Subject: Cable Tray Support Review Questions
Comanche Peak Steam Electric Station
Independent Assessment Program - Phase 4
Job No. 84056

CABLE TRAY SUPPORT REVIEW QUESTIONS

Table 2

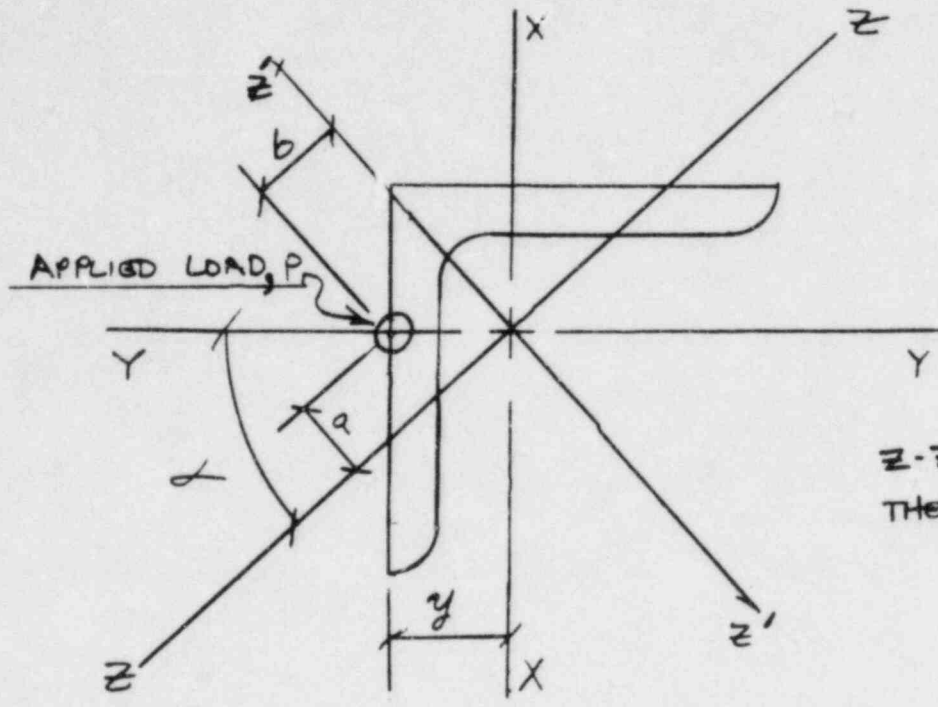
Cygna's review of the cable tray supports included a check of the fire protection weights for those trays within the review scope. The review noted that the total weight for the trays listed in Table 2 exceeded the allowable load of 35 psf specified in section 3.2.2 of the referenced procedure. Section 3.2.2.1 of the referenced procedure states that when the tray support design weights are exceeded due to the application of the fire barrier, the support spans and the tray supports are to be reevaluated for the effects of the actual weight.

Cygna noted that none of the trays which exceeded design loads were checked for span length, nor were the supports reevaluated for the effects of the additional weight.

CP-EI-4.0-49 specifically states that the actual weights, the as-built configuration, and the effects of any CMC's and DCA's shall be considered in the reevaluation of the supports. Cygna is concerned that the cumulative effect of fire protection weights from all trays on a given support may exceed the allowable levels and that the cable tray supports may not be reevaluated for these increased loads.

- (i) The tray spans and supports associated with the cable tray segments listed in Table 2 are adequate to resist the actual applied loads. Please consider the effects of the actual weights for all trays on the affected supports.
- (ii) The effects of all trays which have weights that exceed the design weight due to the application of fire protection are considered in the reevaluation of the cable tray supports.
